Certificate of Appropriateness—Amended

948 N. 34TH ST.

Concordia Historic District

113429 COA Railings and Garage Rehabilitation

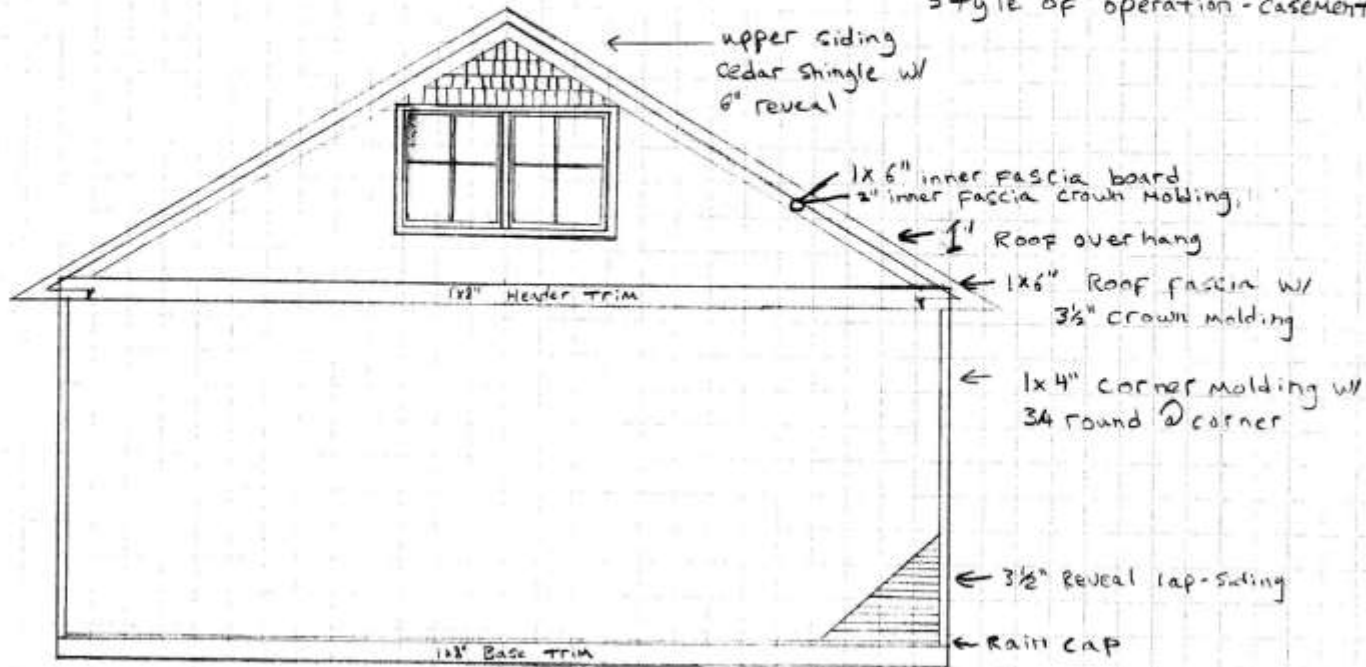
Rear garage looking north. A prior owner had installed stamped metal panels to the exterior. Panels on the shown elevation may remain, on the condition that they are painted and that the existing window is restored.

South Face Plan*

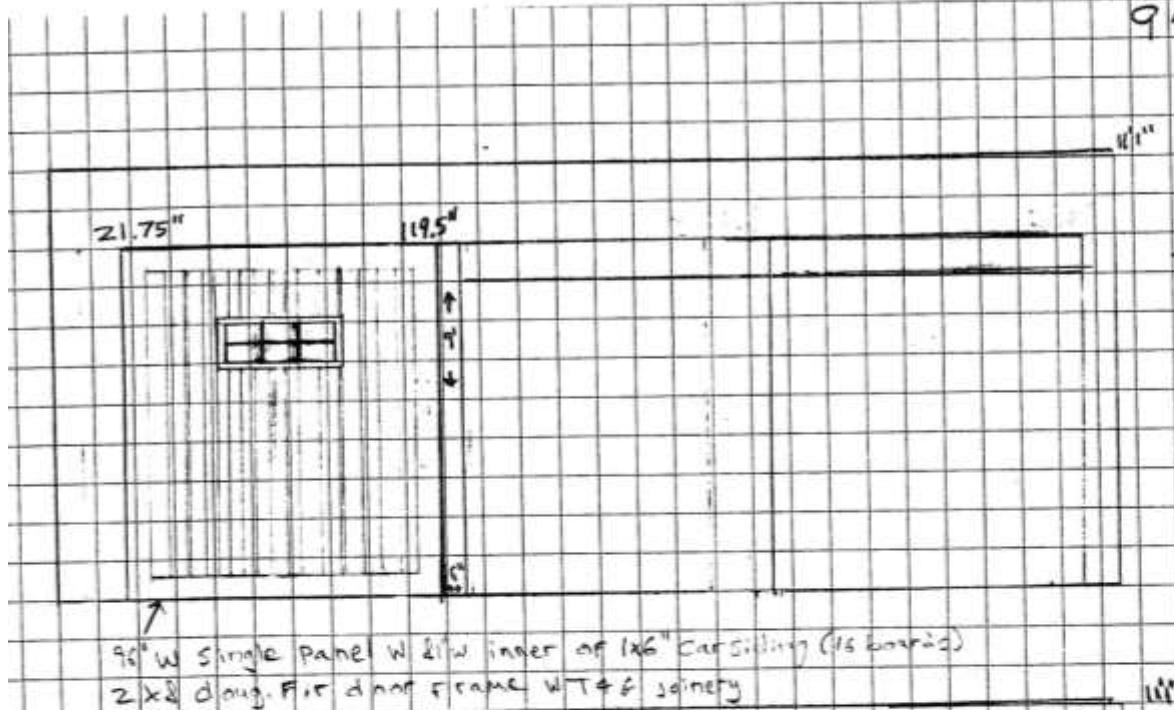
The new windows on this elevation are optional, but must be all wood, per page 2. If these windows are not installed, the existing window must be retained and restored (see pages 3 and 9). The fascia board must still be installed and painted and all siding must be painted.

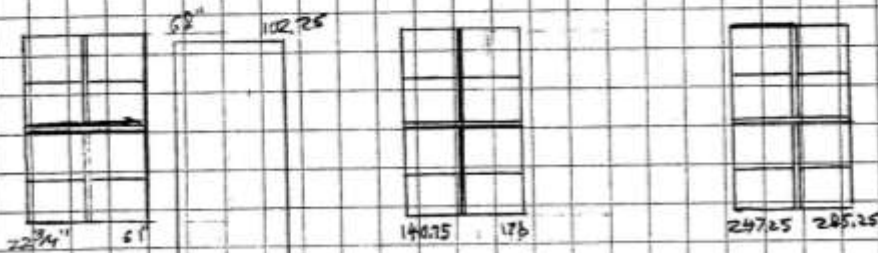
- CURRENT TWO CAR
door opening sealed
& sided w 3 1/2" lap
Siding over 16" center
2x4" frame

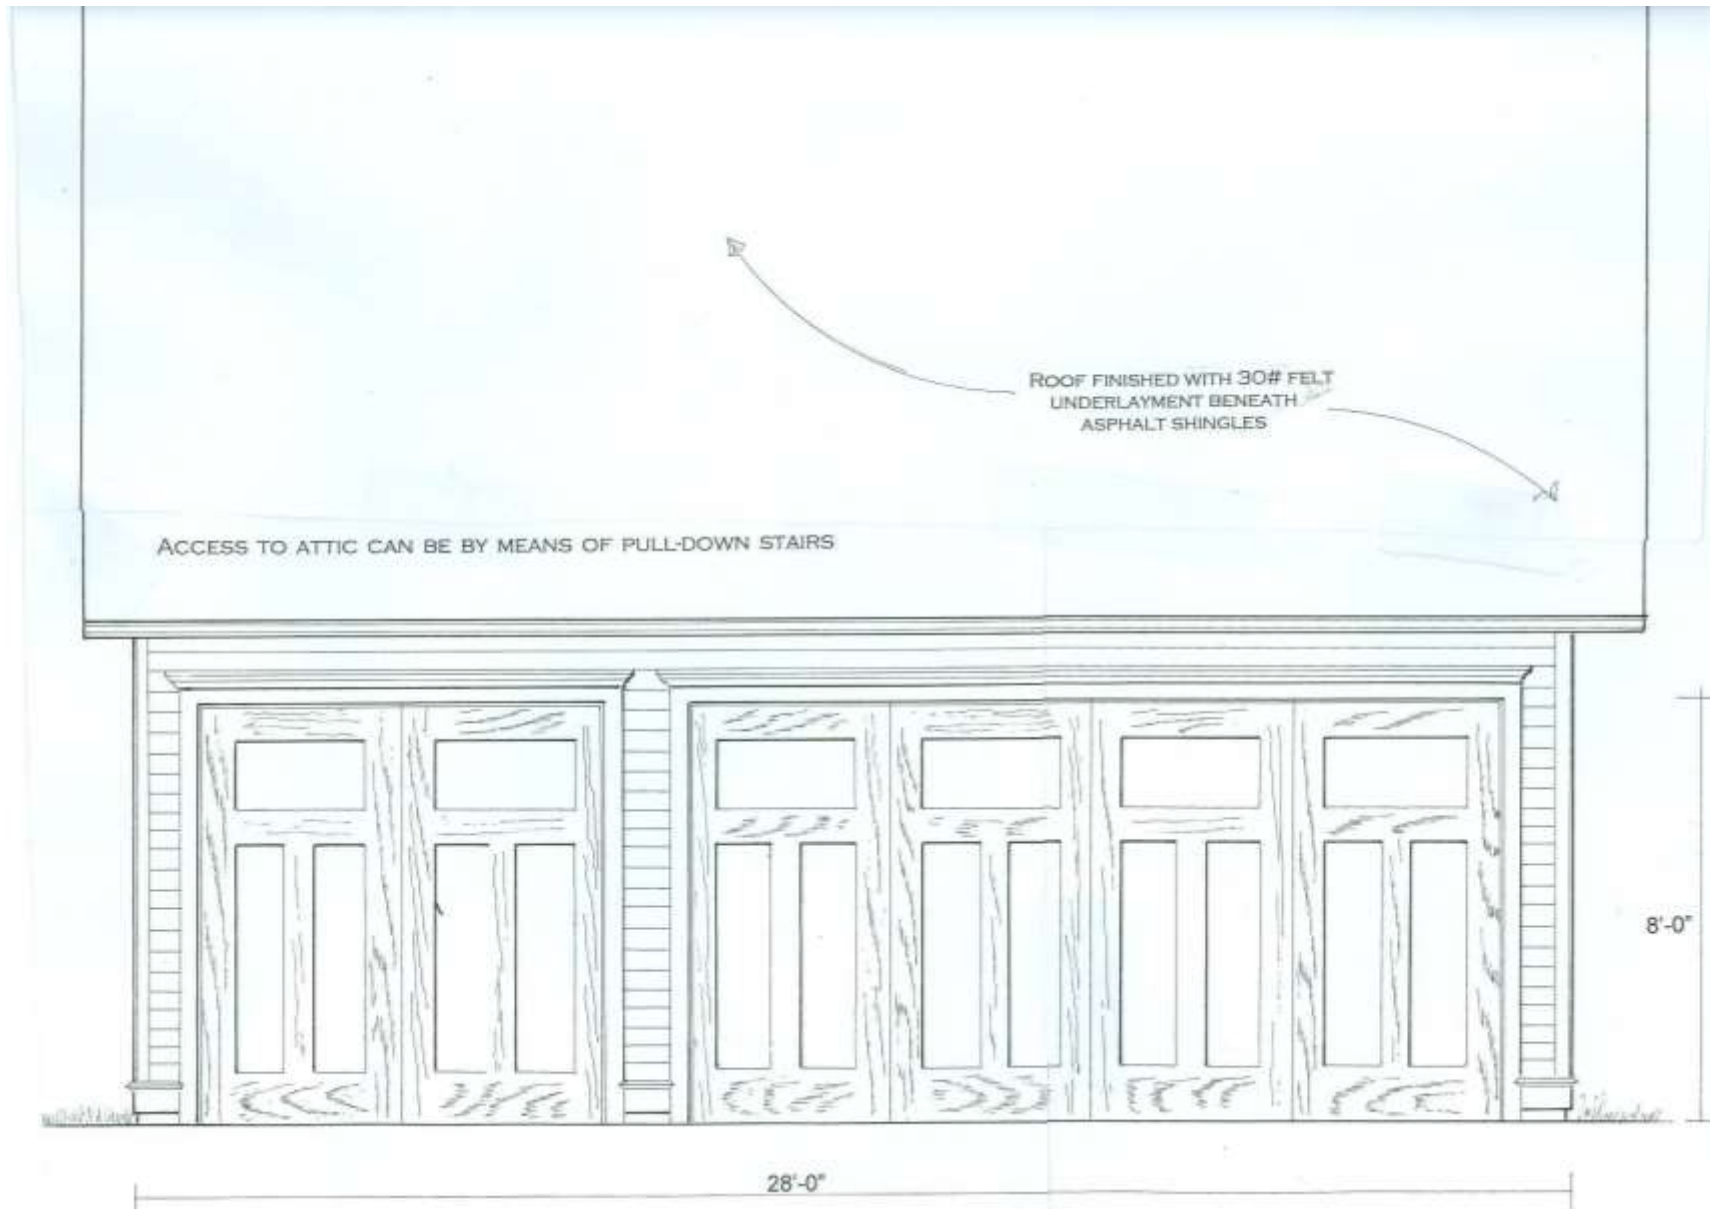
All work on this page is required to be completed. A proper garage door must be installed. It shall be in the designs shown on pages 6, 7, or 10. The mechanism of operation is at applicant's discretion.

Applicant originally preferred tip-up garage doors but has now decided on swing open bi-fold doors as seen above.

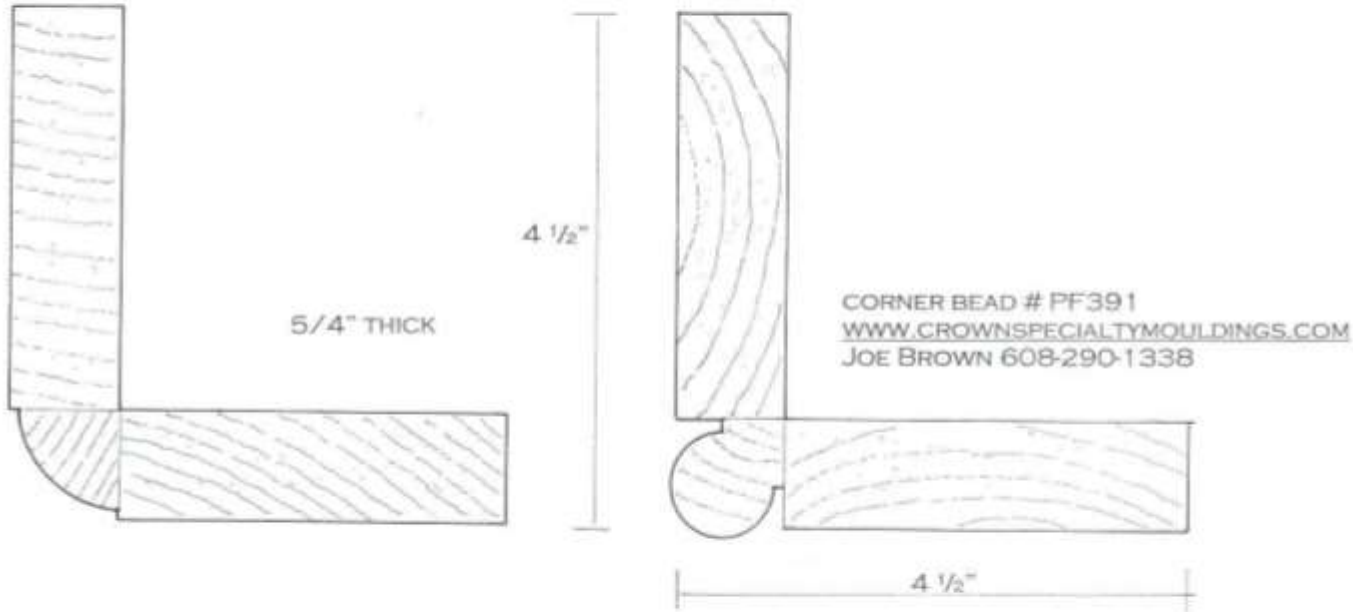
Sample garage with required corner board and water table detail. This type of garage door may also be used in south garage door opening or all existing and former openings.

WINDOW AND DOOR TOP
SECTION AND ELEVATION
CORNER BOARD DETAIL

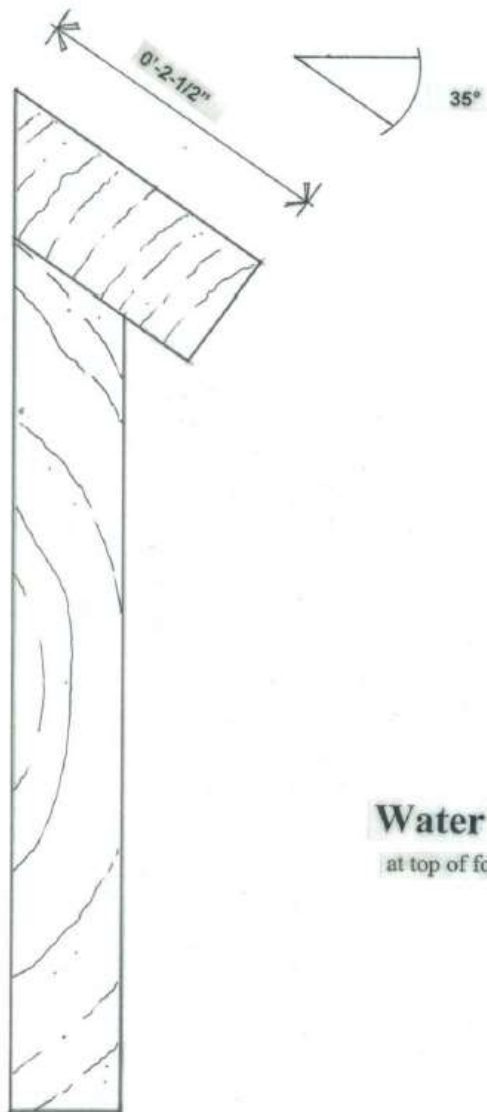
CHOOSE EITHER THE CORNER BEAD
DESIGN (R) OR THE 1/4 ROUND DETAIL (L).
THE CORNER BEAD DESIGN TYPICALLY
SPEEDS CONSTRUCTION AND GIVES A FINE
FINISHED APPEARANCE.

Appropriate corner board details. Required.

Required water table feature at top of foundation. Smooth, knot-free, finish-grade cedar wood or smooth cementitious plank (no artificial graining) must be used.
